City of Albuquerque

RE: DRAINAGE PLAN FOR OFFICE BUILDING @ SANDIA RESEARCH PARK
LOT 1, BLOCK 1 (M-21/D5D)
ENGINEER'S STAMP DATED SEPTEMBER 23, 1988

RE: DRAINAGE REPORT SUBMITTAL OF SANDIA RESEARCH PARK RECEIVED
APRIL 13, 1987 FOR FINAL PLAT AND ROUGH GRADING PERMIT APPROVAL
(M-21/D5)

DRAINAGE REPORT
for
SANDIA RESEARCH PARK
Albuquerque, New Mexico

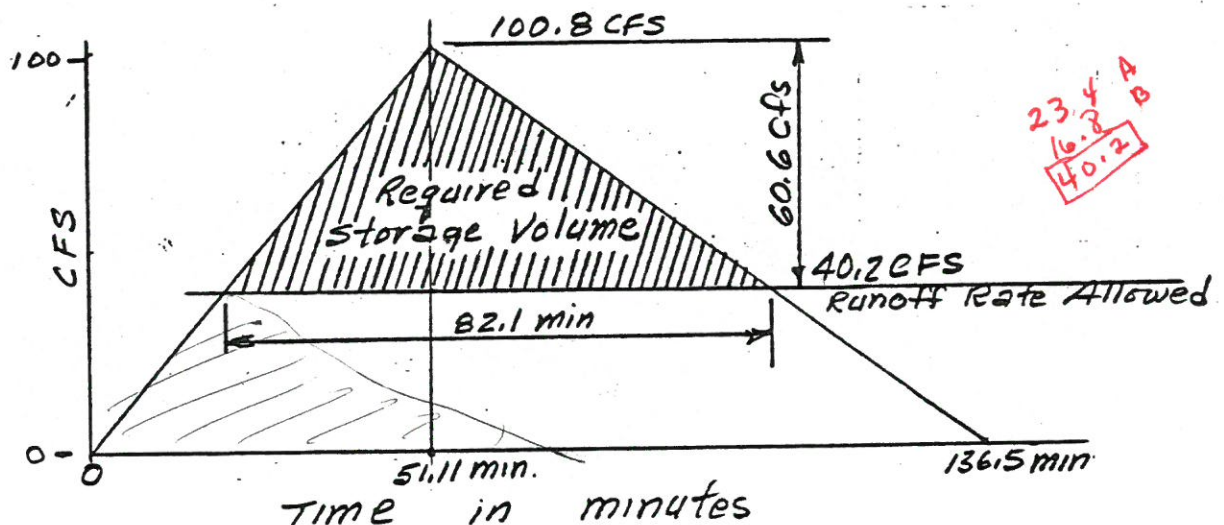
must use
24 hr storm

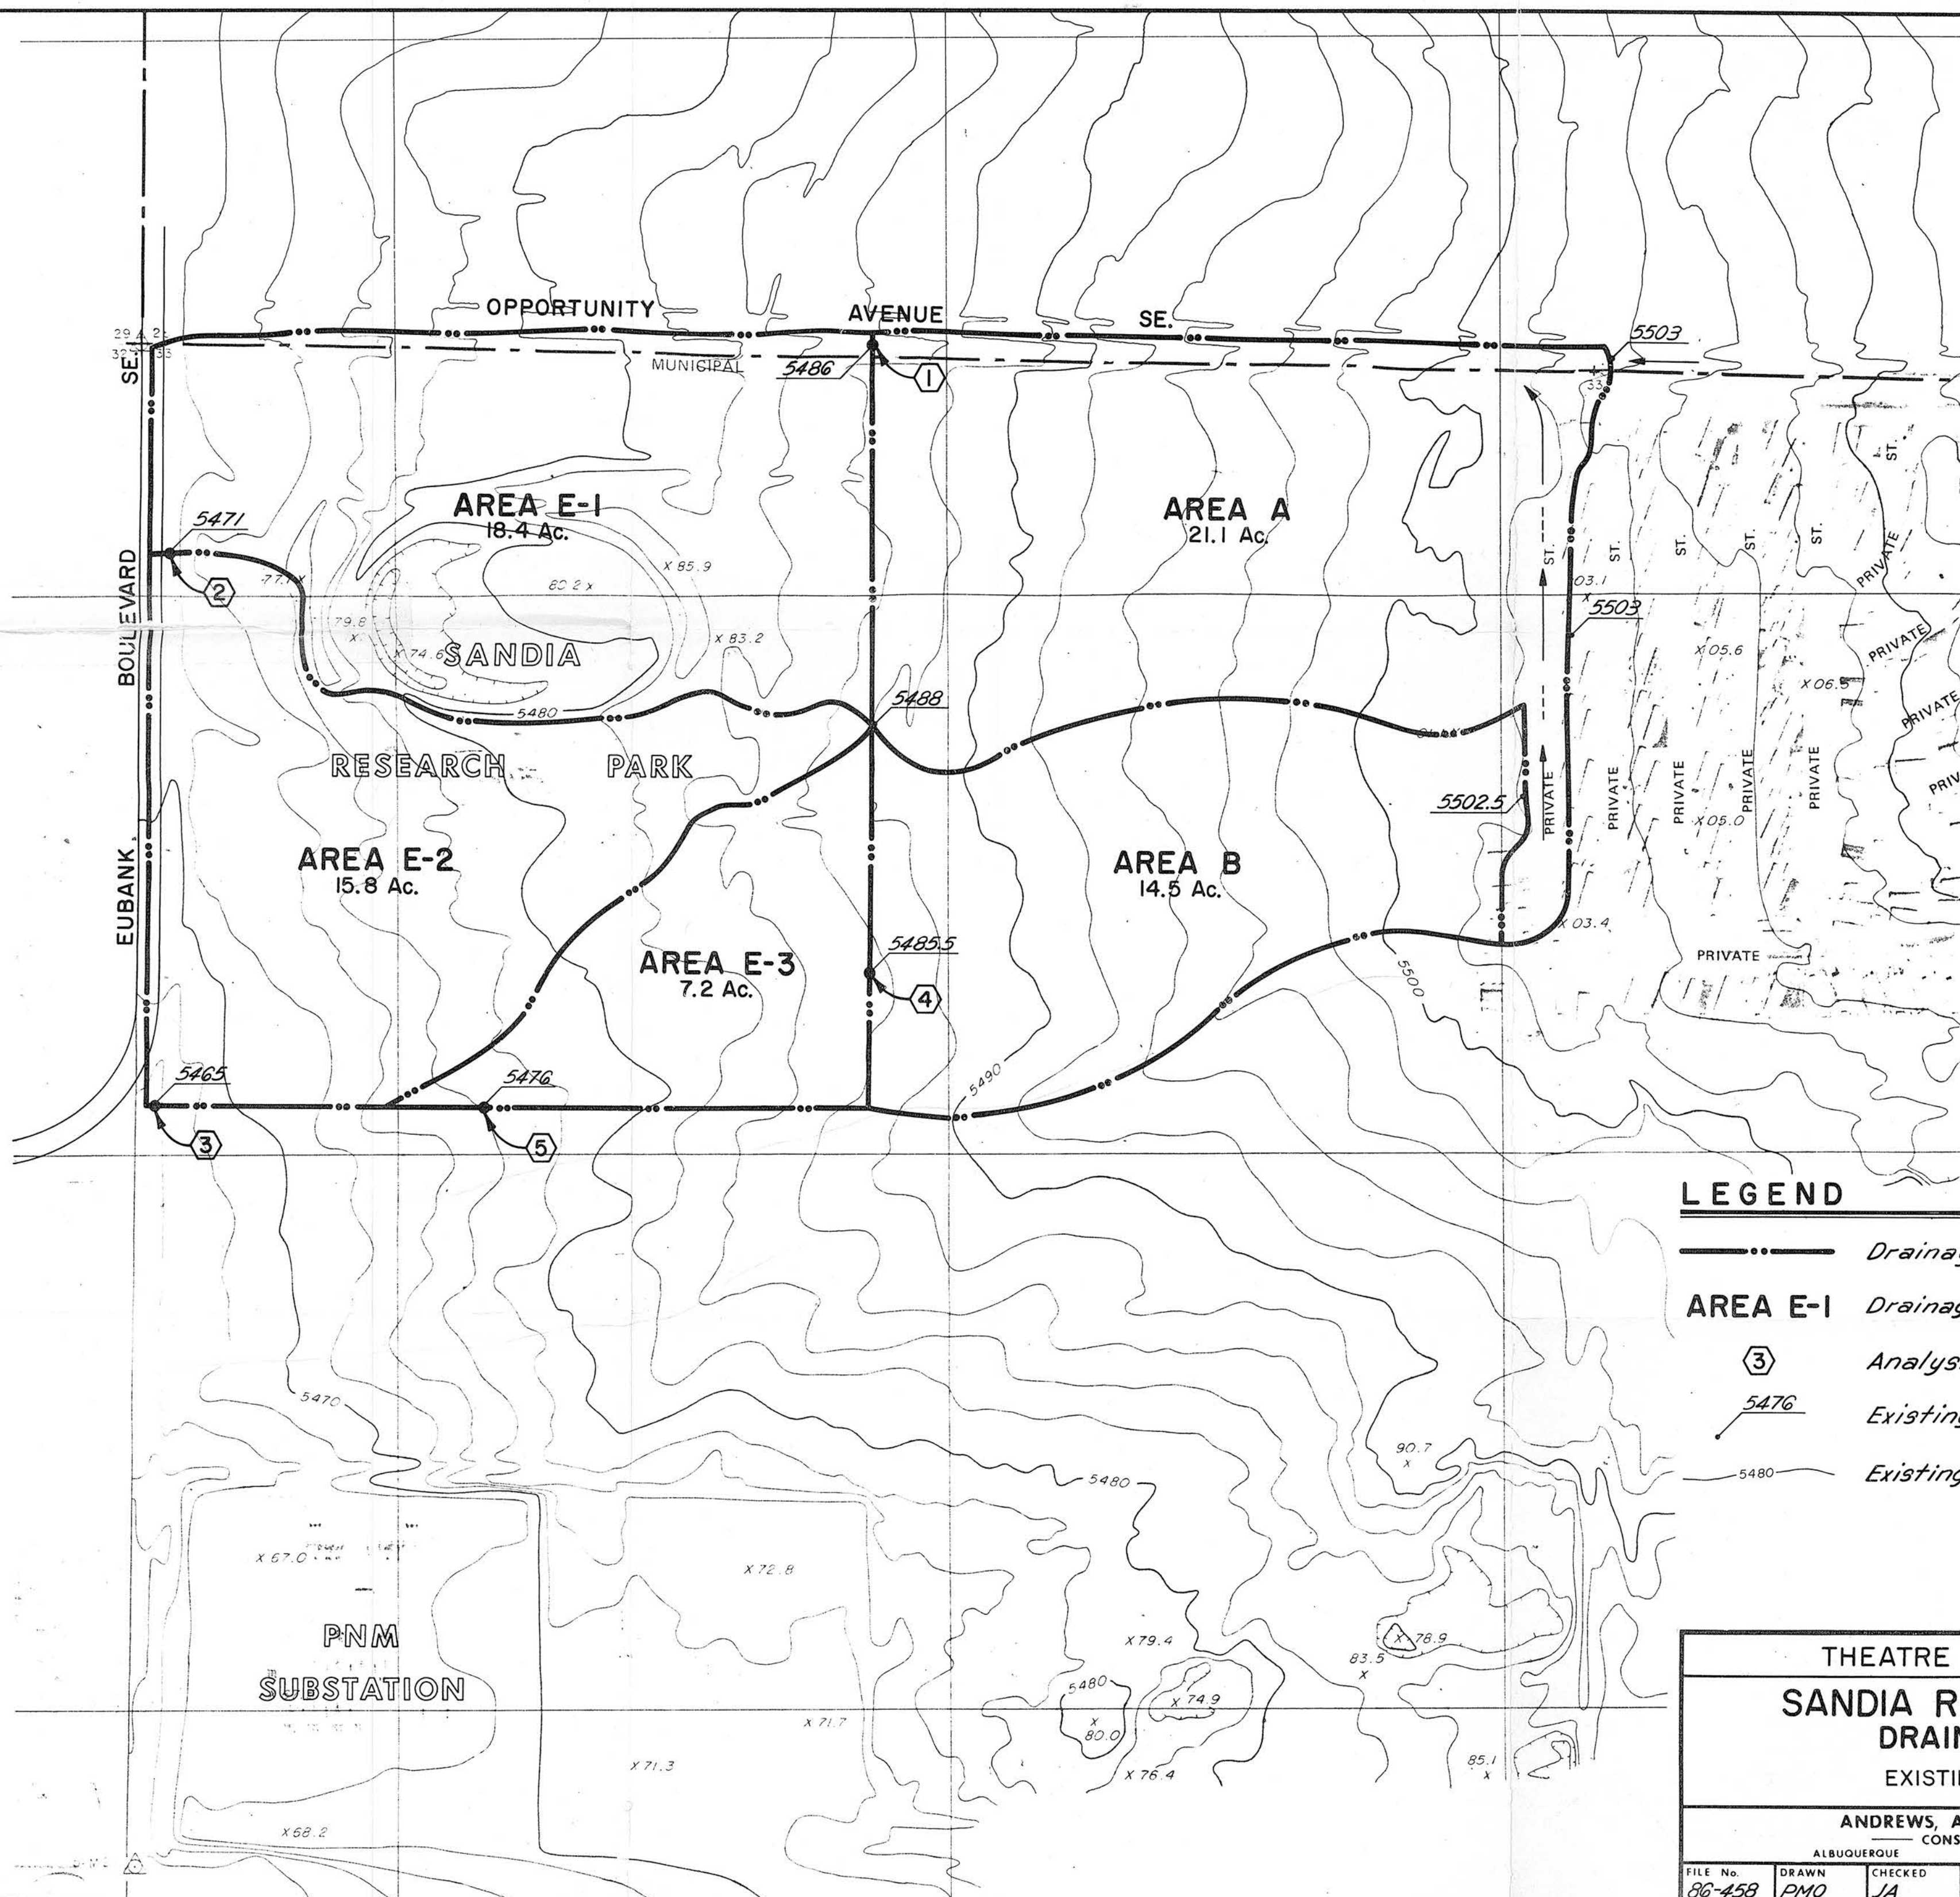
need pond volume calculations
